Referee 2: Tom Walski

First of all, the authors would like to thank the reviewer for taking valuable time to review and for the critical assessment of the paper.

Figure 2: a) Metal concentration in bulk water during trial durations, b) metal concentration equivalence at 1.0 NTU

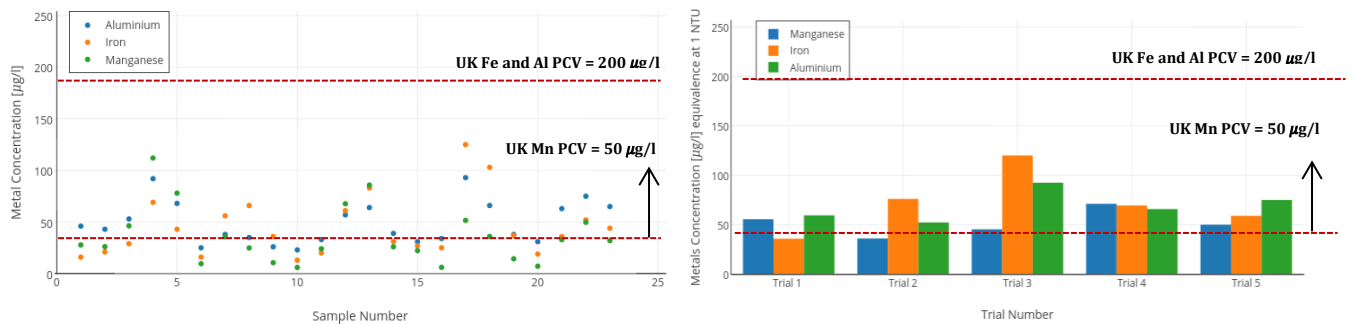
Comment 2: The rapid increase in turbidity in the months after the cleaning indicates that there is some source of the solids causing the turbidity. Without knowing the nature of the solids, it is difficult to determine its source. What did the solids look like? Airborne particles, treatment plant floc carryover, manganese solids, asbestos particles or microbial growth.

C2 Ans: The following has been added to the discussion, it should be noted that conclusion cannot be drawn based on the data collected.

Results of metal samples during trials are shown in figure 2. Figure 2a shows all metal samples during trials where the concentration of manganese (Mn) was high and occasionally exceeding the UK regulatory prescribed concentration value (PCV) value of 50 µg/l. Iron and aluminium concentrations in the bulk water is also shown to be significant, although well below the UK PCV limit. Figure 2b presents the results for calculated metal concentrations for an equivalent 1.0 NTU limit. Manganese PCV is likely to be exceeded during all trials at this threshold suggesting high Mn content in the bulk water. From this it could be suggested that the accumulation or fouling effects are driven by manganese and other metal (e.g. iron and aluminium) precipitation from the bulk water which is consistent with previous research findings (Boxall et al., 2003; Husband and Boxall, 2011; Seth et al., 2004)^{1,2,3}. However, a complete conclusion about inorganic particles responsible here for discolouration risks cannot be drawn from this sampling study alone as undisturbed sampling data from trunk main were unavailable. Also the previous work has indicated that biological processes impact on material accumulation and hence its influence discolouration risks as well (Gauthier et al., 1999; Husband et al., 2016)^{4,5}.
